END OF PRODUCTION NOTIFICATION

EOP No.: EOP190601

Obsolescence of Output Module SM-ODC5F

SM-ODC5F

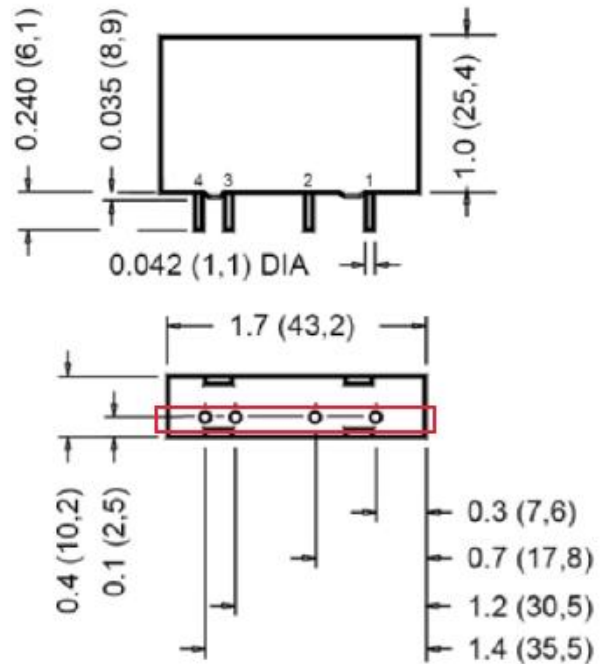
The discontinued module can be replaced by part number **M-ODC5F**, which has the same electrical specifications, same pinout and same overall mechanical dimensions. The main difference is the position of the pins with respect to the plastic housing and the absence of a locator pin, as shown in the following images:

Obsolete Part Number	Suggested Replacement	Comments
SM-ODC5F	M-ODC5F	Same electrical specs and pin layout, but there is no pin locator.
